REGULATOR INFORMATION DISTRIBUTION SYSTEM (RIDS)

SUBJECT: Forwards response to SER Outstanding Issue 26, consisting of write-up to be included in Subsection 9.6.3 of Revision 6 to design assessment rept.

SUSQUEHANNA STEAM ELECTRIC STATION  
SER OUTSTANDING ISSUE # 26  
ER100450                      FILE 841-2  
PLA-804

### 9.6.3 Statistical Evaluation of the GKM II-M Resultant Bracing Force Data

Frequency Distribution of the  
Bracing Forces for 1/6 MSL-Breaks  
Tests 13 through 18

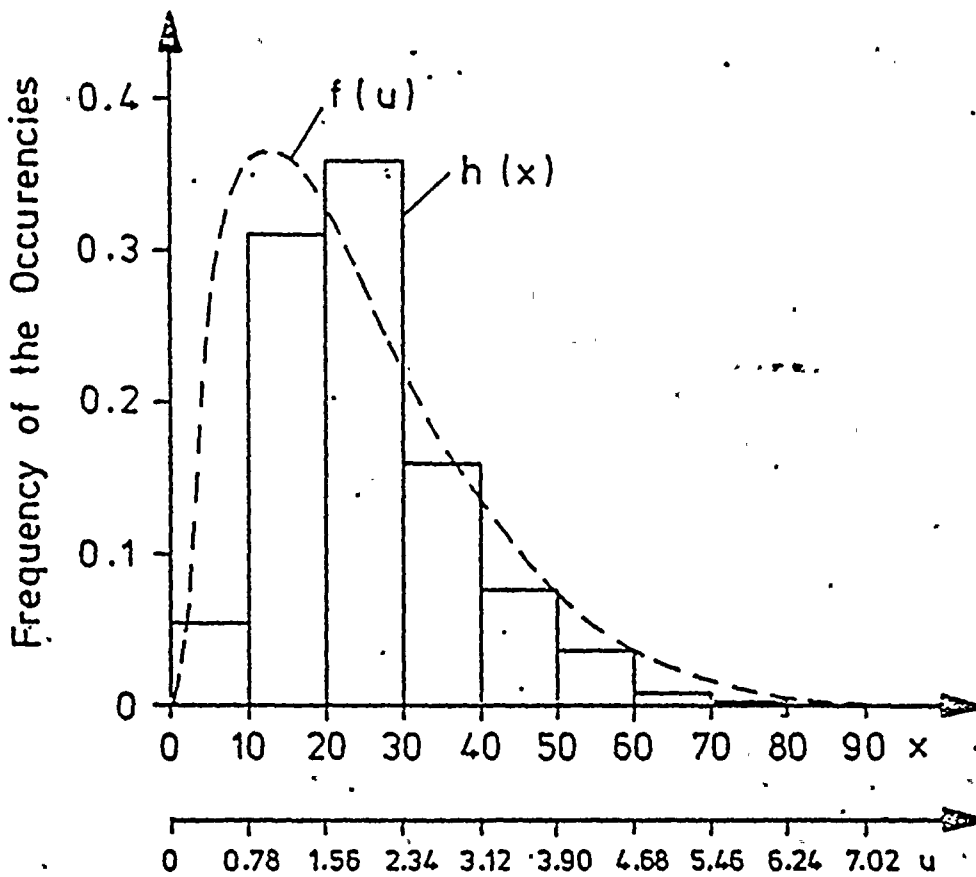
Figure 1 compares the theoretical with the measured relative frequencies. Thus, the function  $f(u) = ue^{-u}$  provides a conservative distribution.
